WELLS PARK WATERPLAY

5/16/11 PROJECT #568503 May 16 2011

(Wells Park Water Play T.I.)
06/13/2011-201191148
Randy Rudy M.C.P.
Plans Examiner
(505) 924-3961
rrudy@cabq.gov
www.cabq.gov
PLAN EXAMINERS AVAILABLE MONDAY THRU FRIDAY 08:30 TO 11:30

4 SPRAY PARK EQUIPMENT ROOM PLAN - MECHANICAL
 SP1 SCALE: 1/4" = 1'-0"

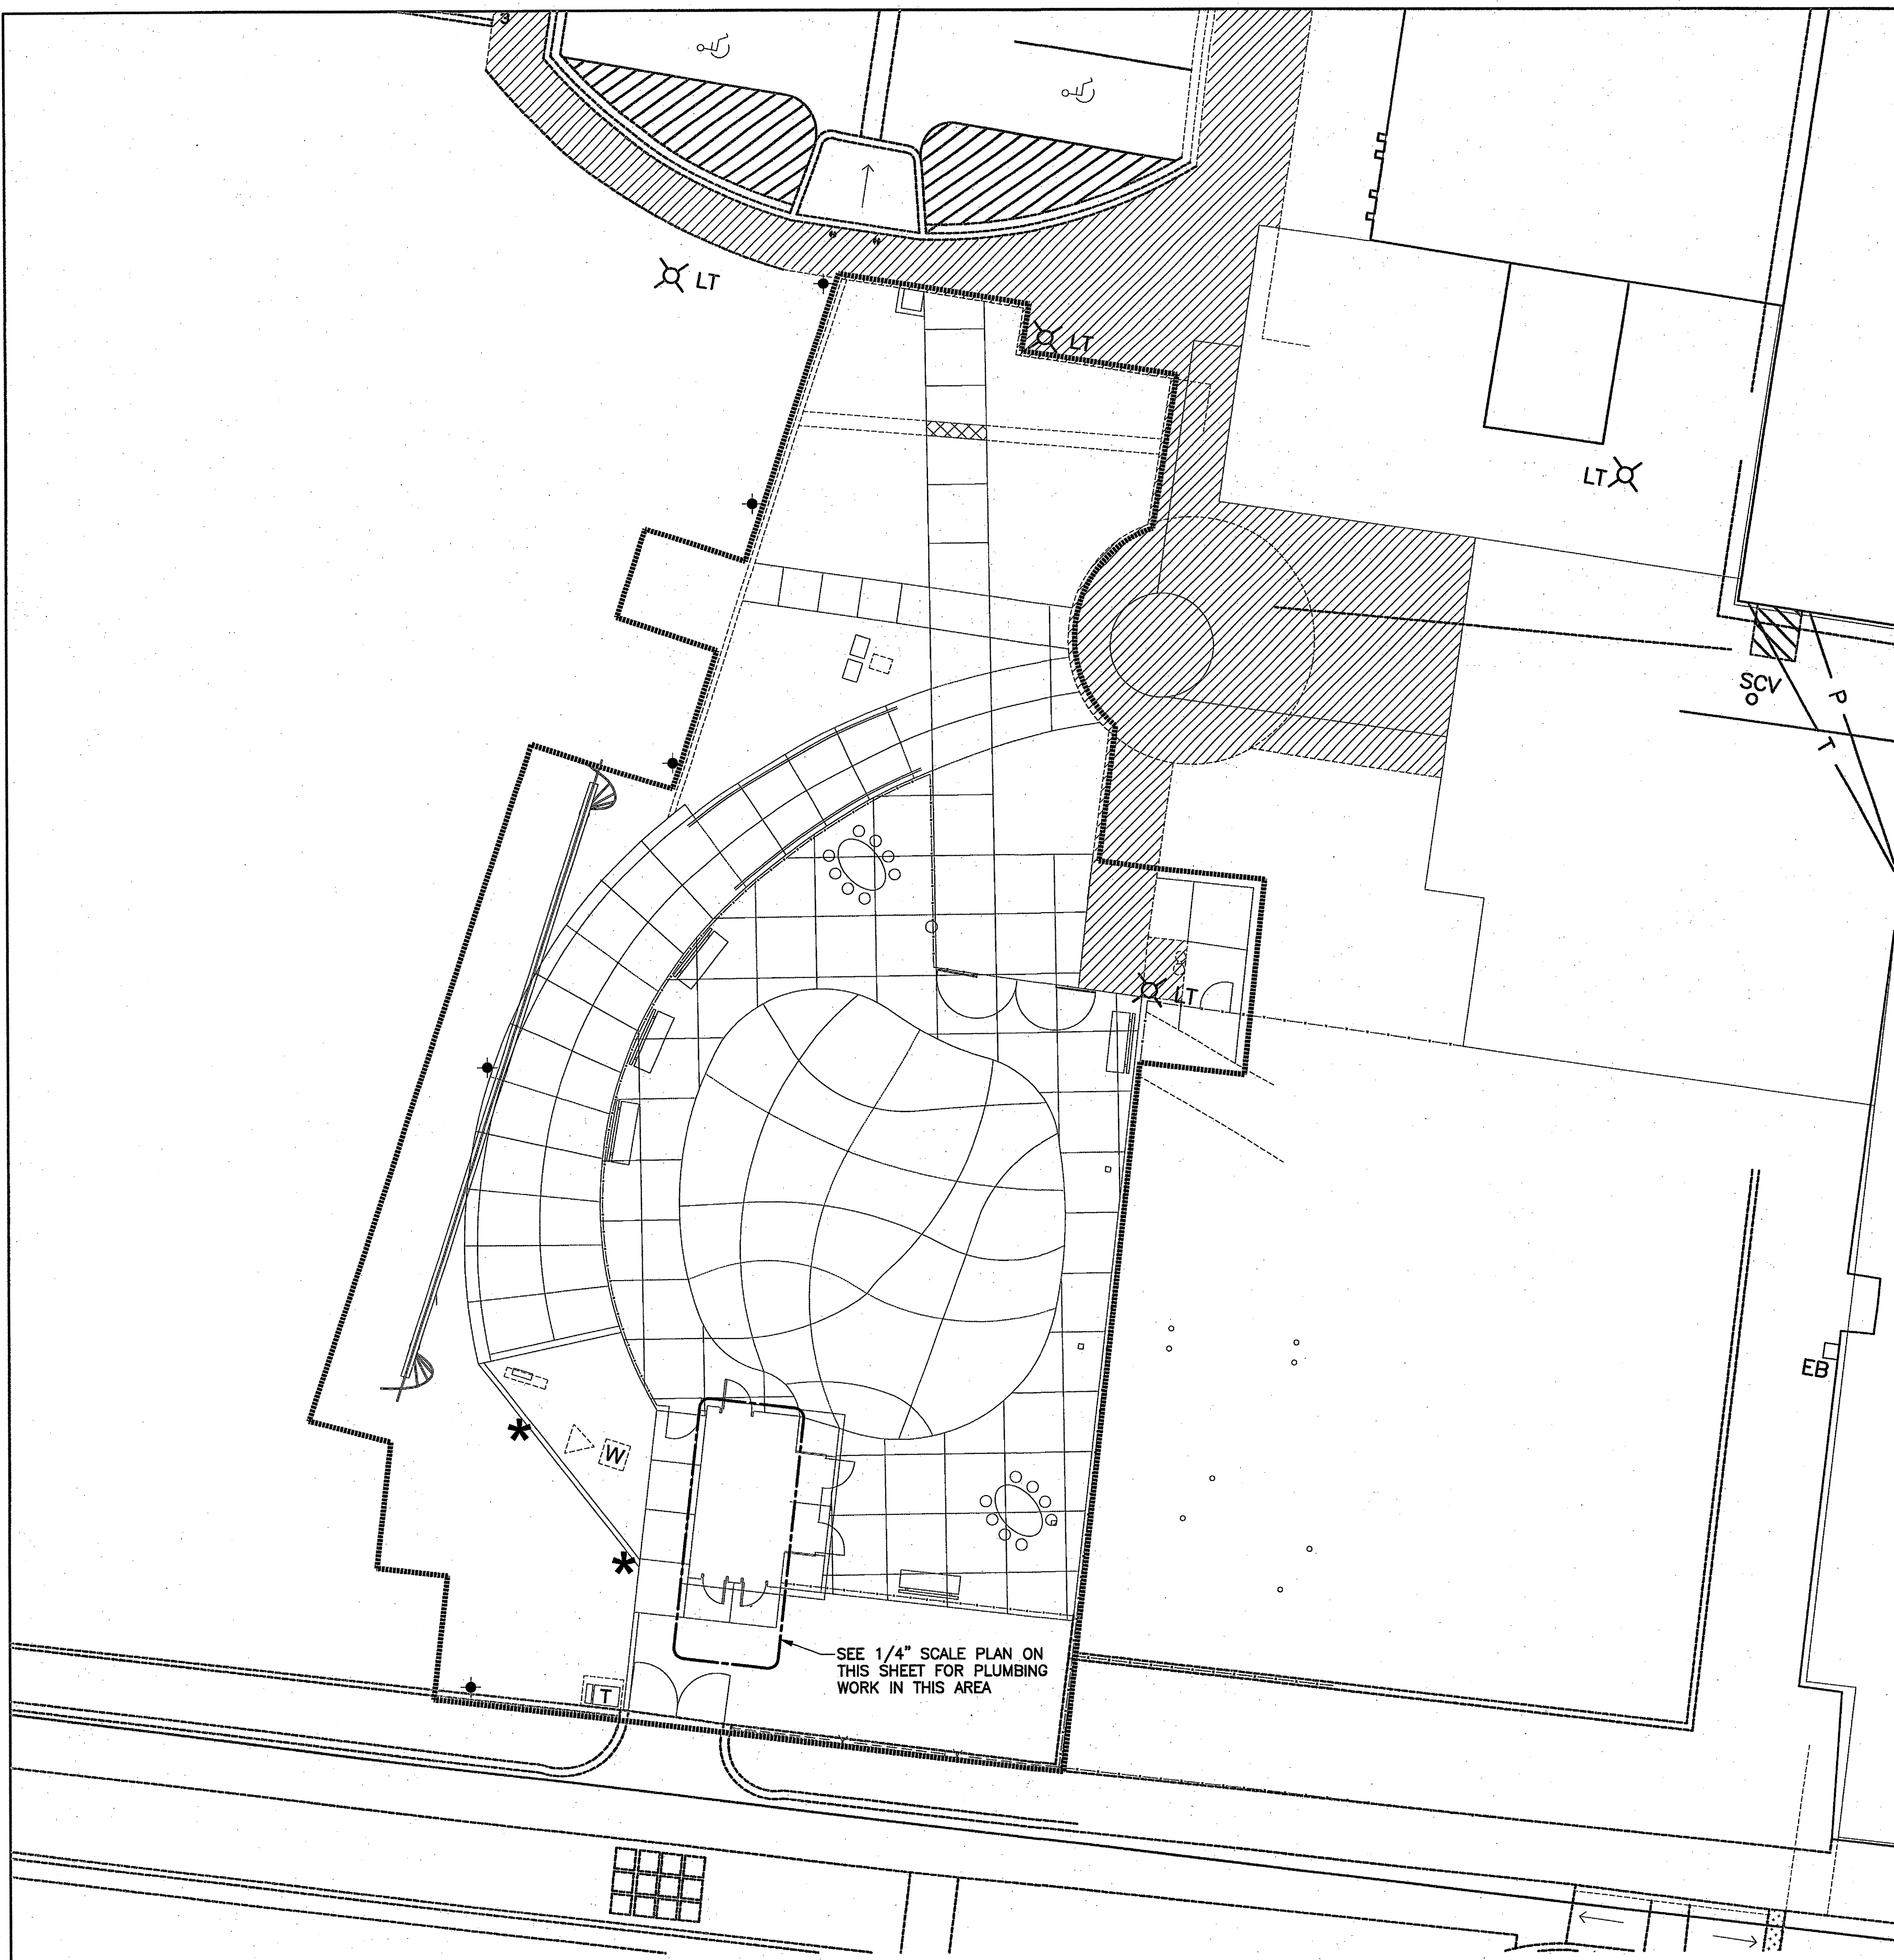
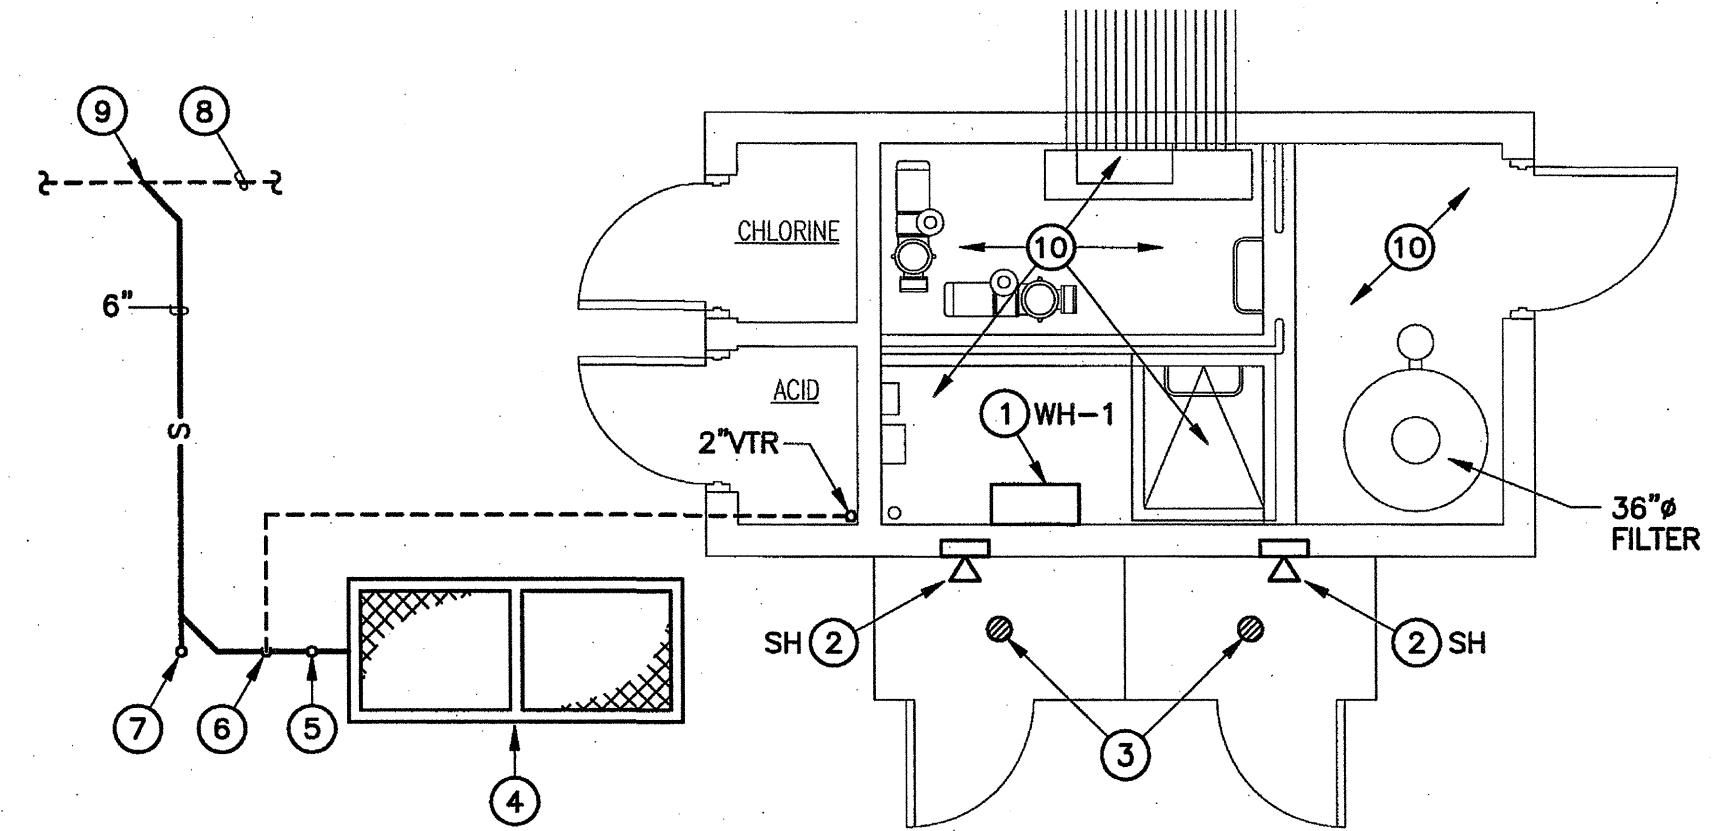
2. Sheet 13 of 18. Please provide minimum performance of water heater as per 06 IECC Table 504.2.
- UPC
1. Sheet 12 of 18. Detail C3; please specify storage amounts of chlorine & acid as per 03 IFC Table 2703.1.1 (2) and Chapter 31.
